RE: Group Principal Objection – DA2023/0246, No. 18 Hillcrest Ave, MONA VALE

Thank you for the opportunity to submit a planning submission concerning **DA2023/0246** at **No. 18 Hillcrest Ave, MONA VALE**. I note the DA proposes alterations and additions, involving construction of a secondary dwelling.

| DA description: | Alterations and additions to residential development – construction of a secondary dwelling. |

Figure 3: Existing rear setbacks - No. 16 (left), No. 14 (centre) (Source: iObject 2023)

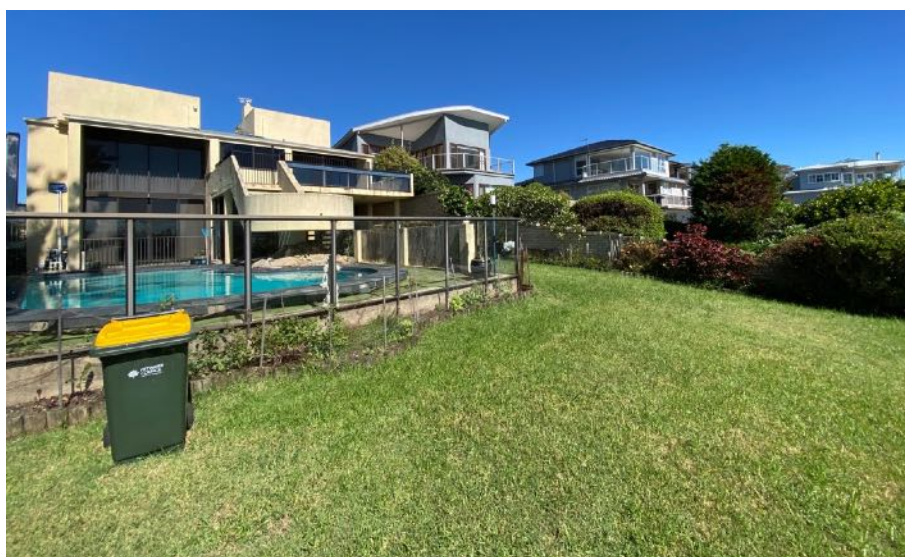
Bungan Headland (on the northern end of Bungan Beach) is similarly typified by significant rear setbacks from the cliff edge (see Figure 2). This creates a green corridor sloping down to the beach, providing ample curtilage and effective scenic protection of the cliff edge and associated rock features. Similarly,

The siting of the proposed secondary dwelling, compared to the general pattern of headland development is regarded as being in opposition to typical rear setback patterns. The new structure will thus become the dominant feature when viewed from Bungan Beach and the Ocean, plus being highly visible from the Bungan Headland.

Detached secondary dwellings are not evident within the established rear setback pattern of surrounding properties (i.e. along the eastern edge of North Mona Vale Headland). A tendency to step-down sloping sites is also the local custom when faced with a sloping site, as demonstrated by No. 12. In contrast, the proposed secondary dwelling seeks a large undercroft space beneath the elevated rear deck, which will likely cause an aesthetic detracting from the scenic values described.

Proposed Solution: Ensure any amended plans fully reflect the type and nature of development evident within the street, taking into consideration scenic protection values emblematic of Bungan Beach and its headlands.

Figure 11: Base of the Beach Track with evidence of landslip below (Source: iObject 2023)

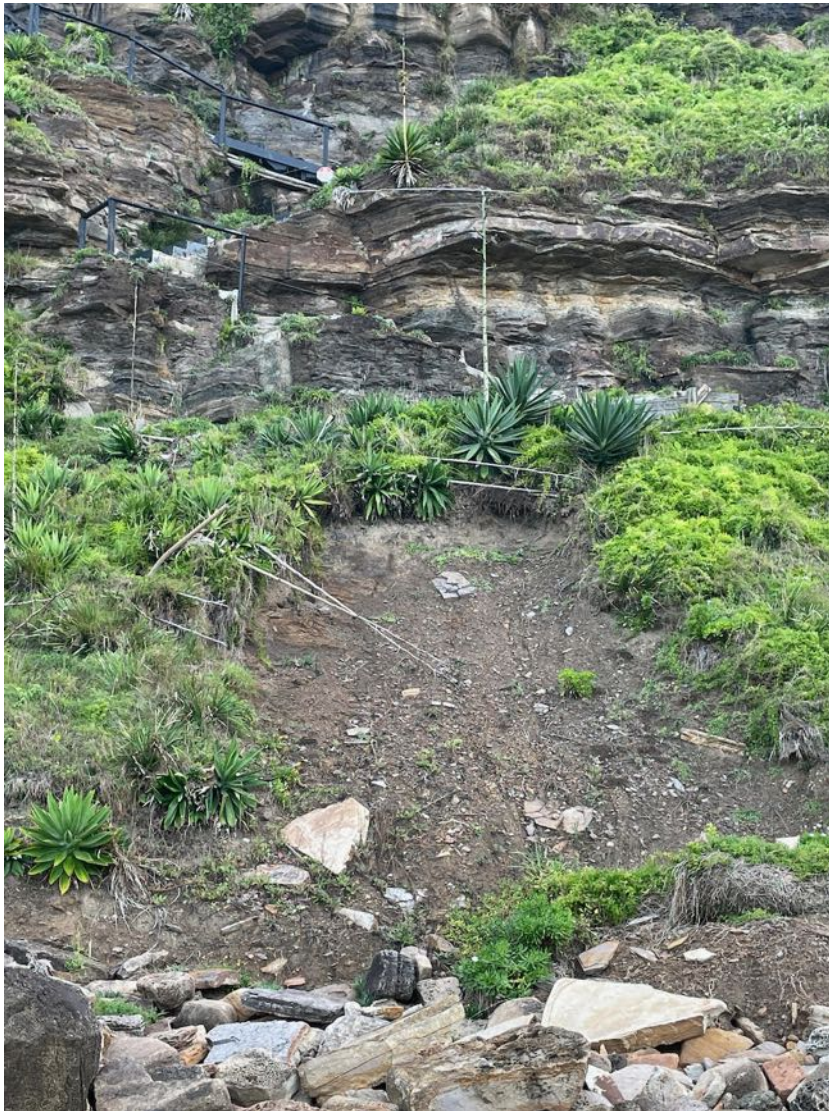
Corroboration of the Applicant's claim that the proposal will unlikely cause detrimental increases in coastal risks to other development or properties may not be upheld by other geotechnical and coastal hazard experts. The location of the proposed new structure seems to discount specific design principals for Coastline (Bluff) Hazard sites (DCP B3.4), thus greater weight needs to be applied to ensuring a measured response is applied in reducing the risk and costs of landslip.

Given the topography and history of the site, together with the configuration and weight of that proposed, concern is raised the building may in fact increase the level of landslide risks to No. 154 Barrenjoey Road below, as well as No. 12 adjacent. Evidence of local cracking and movement highlights this possibility, offering a clear picture of the tenuous soil structure under which the development is proposed (see **Figure 12**).

Proposed Solution: Enforce a 10-metre rear building setback from the bluff edge, consistent with surrounding development patterns.
